Re: Rapiscan AIT System Radiation Survey Reporting

FORM R-0646-1 (Single Pose)

**R-0646-1 Addendum
(Documentation Errors)**

1. In Beam Dose Measurement: Survey Table. 1

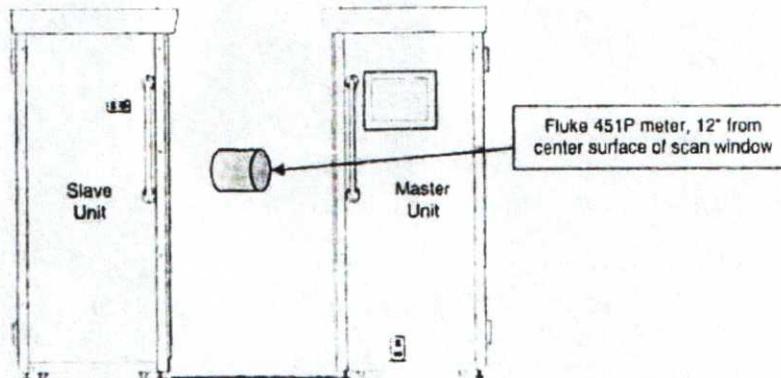
1. No value indicated for background radiation. Typical values range from 7uRem/hr to 13uRem/hr at sea level. Note: Absence of value has no adverse impact on calculations.
2. Technician indicated scan time as 7 seconds. Correct scan time is 3 seconds.
3. TABLE 1: Incorrect presentation of data in Column 3 for Measured Exposure. Indicated values are 26uR and 37uR. Corrected values are 2.6uR and 3.7uR. The values were corrected by technician when calculating Effective Dose.
4. TABLES 2 and 3: Incorrect presentation of data in Column 6 for Dose Equivalent. Indicated values are .18 uRem. The correct value should be 1.8 uRem.

The service technician should attend refresher training.
